# HISTORIC AND DESIGN REVIEW COMMISSION

January 20, 2021

**HDRC CASE NO:** 2020-580  
**ADDRESS:** 215 LOWELL ST  
**LEGAL DESCRIPTION:** NCB 2985 BLK 3 LOT 10  
**ZONING:** MF-33, H  
**CITY COUNCIL DIST.:** 5  
**LANDMARK:** Individual Landmark  
**APPLICANT:** Elaine Lutton/LUTTON PROPERTIES & LUTTON ELAINE & LUTTON RICHARD MD  
**OWNER:** Elaine Lutton/LUTTON PROPERTIES & LUTTON ELAINE & LUTTON RICHARD MD  
**TYPE OF WORK:** Dormer installation and Historic Tax Certification  
**APPLICATION RECEIVED:** December 17, 2020  
**60-DAY REVIEW:** Not applicable due to City Council Emergency Orders  
**CASE MANAGER:** Rachel Rettaliata  
**REQUEST:**

1. Install a rear dormer.
2. Receive Historic Tax Certification.

**215 Lowell St**  
**Addition of Bump Out, Rear Roof**  
**Specifications**

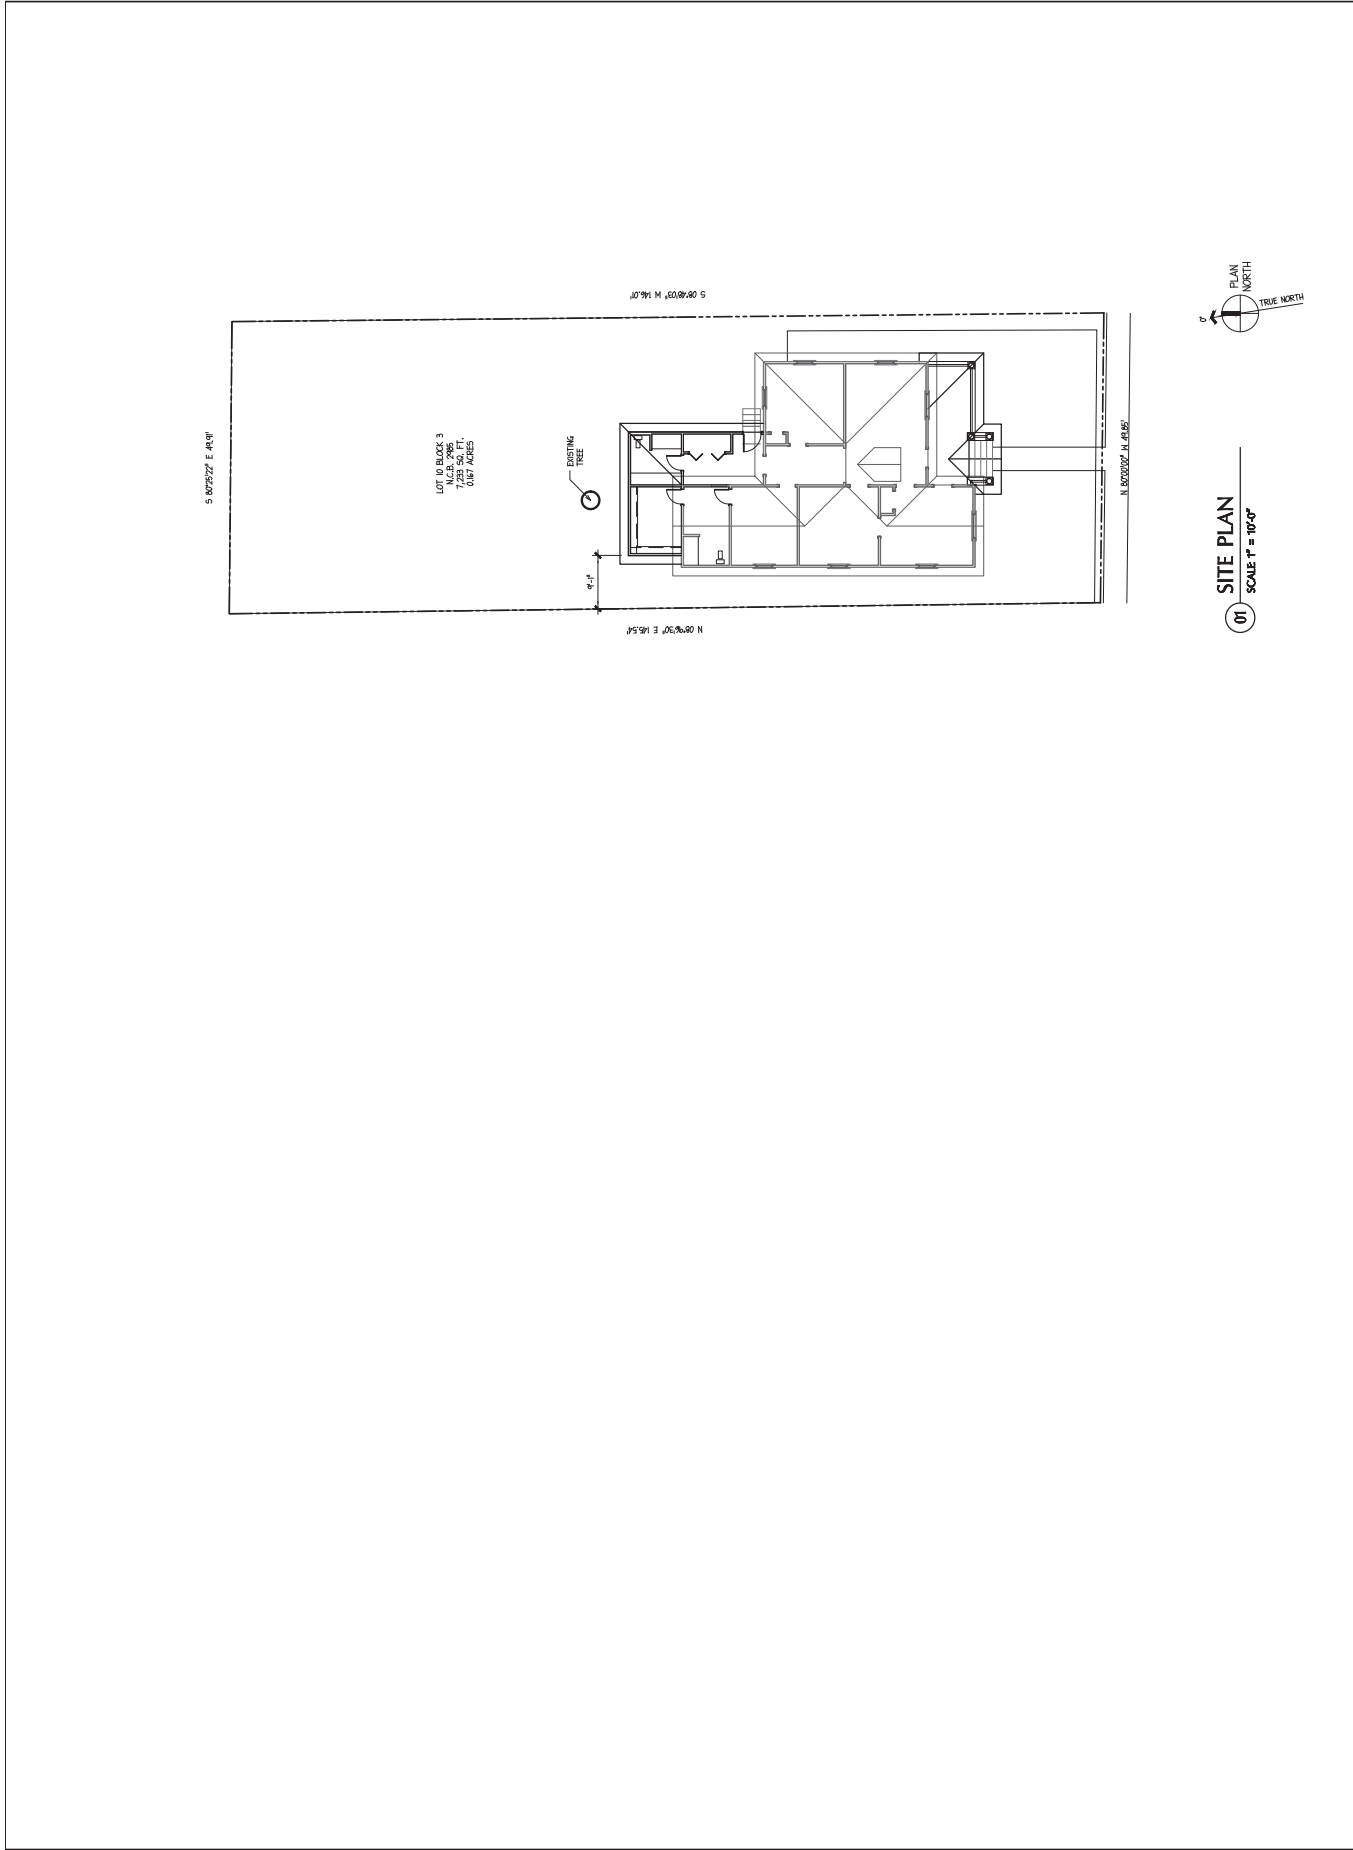
- b. REAR DORMER INSTALLATION – The applicant has proposed to install a dormer at the rear of the house to allow for interior egress from a bedroom. The applicant has proposed to relate the proposed dormer to the existing dormers through the use of cedar shingles and standing seam metal roofing to match existing. The applicant has proposed to install an existing salvaged wood window found on the property in the dormer. According to Guideline 3.A.ii for Exterior Maintenance and Alterations, the original shape, line, pitch, and overhang of historic roofs should be preserved when replacement is necessary. Guideline 3.A.iii for Exterior Maintenance and Alterations states that distinctive roof features such as cornices, parapets, dormers, open eaves with exposed rafters and decorative or plain rafter tails, flared eaves or decorative purlins, and brackets with shaped ends should be preserved and repaired. Guideline 3.A.iv states that for sloped roofs, salvaged materials should be re-used on roof forms that are most visible from the public right-of-way. Match new roofing materials to the original materials in terms of their scale, color, texture, profile, and style, or select materials consistent with the building style, when in-kind replacement is not possible. As the proposed dormer will not be visible from the public right-of-way, will not alter the general roof form, and new roofing materials will be installed to match existing, staff finds the proposal appropriate.

Roof will be same standing seam, metal as rear of house.

Cedar shake shingles will be used to match other dormers on house.

Original old wood window found at the home when purchased will be used.
